Our Reference: 41901-03 [ID 980759]
Council Reference: OPW/2023/1350

Re: Response to Information Request for Development Application over Lots 191 & 192 RP 173728, 97 Courtney Drive, Upper Coomera

On behalf of our Client *HB Land Qld Pty Ltd* we make the following response to Council's Information Request, dated 15 December 2023 for the abovementioned Development Application; as allowed by s13.2 & s13.3 of the Development Assessment Rules under the *Planning Act (2016)*.

Table 7.4.2 – Flow width limits for 'longitudinal' flow during MINOR STORM

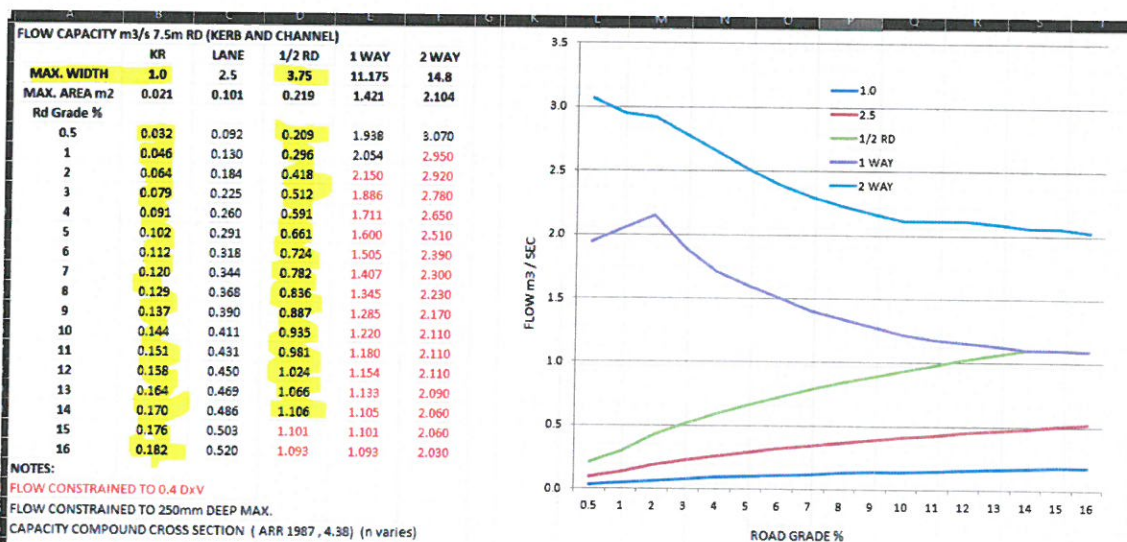
c. The submitted stormwater calculation indicates there will be bypass flows in the minor storm. The applicant is requested to confirm that the pipe sizing caters for the design storm for the development.

The pit and pipe system in the minor storm is NOT DESIGNED to capture 100% of the approach flow at pits. The principle is to capture the flows that are required in minor and major systems to conform with QUDM, refer to Table 7.4.2 below

In GCCC at the nominated grade, these flows are allowed around corners (1.0 wide) and down the street (1/2 road width). The purpose of pits and pipes is to ensure these flow widths are not exceeded, NOT to capture 100% of flows. The bypass flows in the minor storm events are significantly less than these allowable flow widths.

We believe that all minor and major flows have been considered and confirm that all fall comfortably within the QUDM requirements.

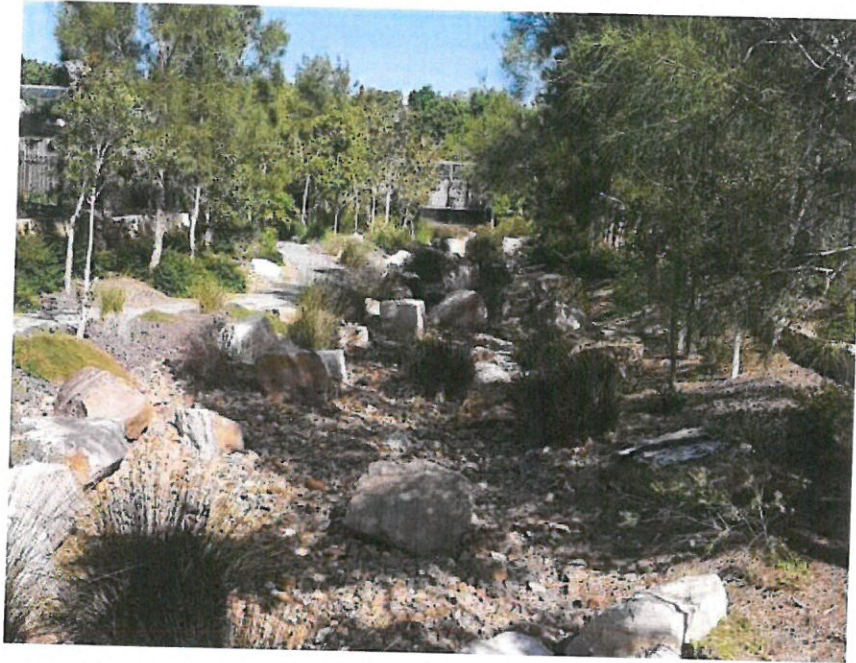
Conditions (2, 5, 49) of the Decision Notice for COM/2019/82 require a natural channel design and rehabilitation of the primary watercourse that flows through Drainage Lot 1007 and into Drainage Lot 1006.

The applicant is requested to amend the drawings to clearly demonstrate the following within Drainage Lot 1007 and Drainage Lot 1006:

- a. *natural channel design incorporating 'chain of ponds' for the primary watercourse, and*
- b. *potential for rehabilitation of the natural channel design consistent with the Statement of rehabilitation intent by Biome Consultancy Pty Ltd, November 2020.*

This is a civilworks application that does not include the landscaping portion for these works, the civilworks component includes shaping and providing scour protection to this area. The landscape components relating the Statement of Rehabilitation intent will be completed under a separate application, where large rocks and planting will occur. We note that earthworks in this area have not changed since the approved preliminary Earthworks plans refer to drawing no 36001-PRE-100 to 105. (**Attachment 2**)

Figure 1: Bulk Earthworks plans showing contours and water flow for Park Lot 1007 as well as landscape treatment for drainage swale.

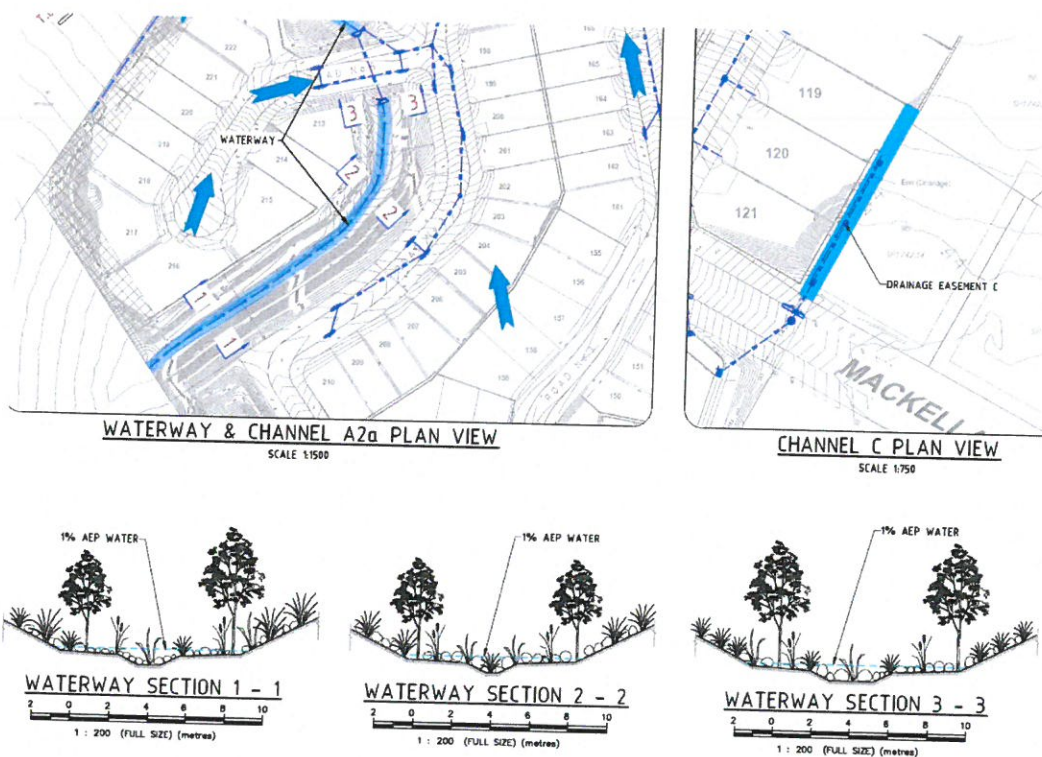
- a. *A minor tributary of Yaun Creek located in the southwestern portion of the subject site is proposed to be reconstructed and realigned. Park Lot 1007 will contain this realigned and reconstructed waterway channel.*
- b. *A number of plans, including the Statement of Landscape Intent, Rehabilitation Management Plan and Stormwater Management Plan within presented final designs to support a natural channel design with riffles and ponds, and selected locations for larger boulders to act as energy dissipators within Park Lot 1007.*
- c. *The current OPW plans do not provide an indication that this will be achieved rather a straight rock lined channel with uniform depth and 1:2 batters.*

- d. The applicant is requested to demonstrate that the final design will achieve a reconstructed natural waterway which will also support the planting of a number of plant strata including larger canopy trees (*Melaleuca* and *Casuarina*) as well as shrub and understory species in accordance with the proposed hydraulic function such as nil impedance of the low flow channel.

This is a civilworks application that does not include the landscaping portion for these works, the civilworks component includes shaping and providing scour protection to this area. The landscape components relating the Statement of Rehabilitation intent will be completed under a separate application, where large rocks and planting will occur. We note that earthworks in this area have not changed since the approved preliminary Earthworks plans refer to drawing no 36001-PRE-100 to 105. (Attachment 2)
